PTO Linkage NSN Correction

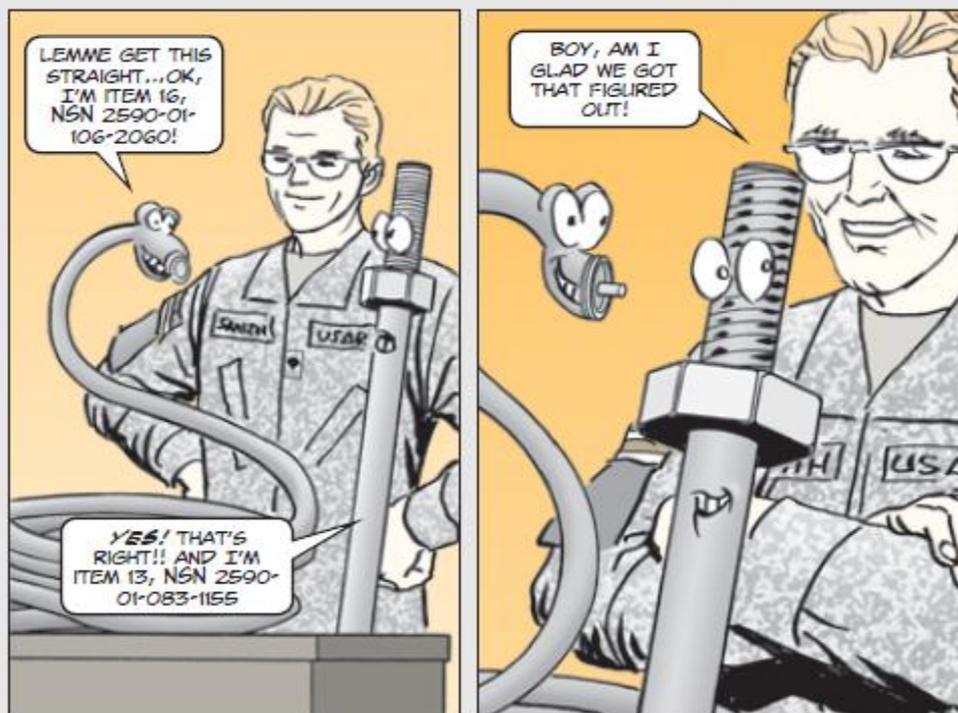
TM 9-2320-272-24P-2 gives the same NSN for Item 13 of Fig 525 and Item 16 of Fig 528. The problem is that these are actually two different items.

We later learned the correct NSNs: Item 13 of Fig 525 is NSN 2590-01-083-1155 (PN 11669342-1) and Item 16 of Fig 528 is NSN 2590-01-106-2060 (PN 11669463).
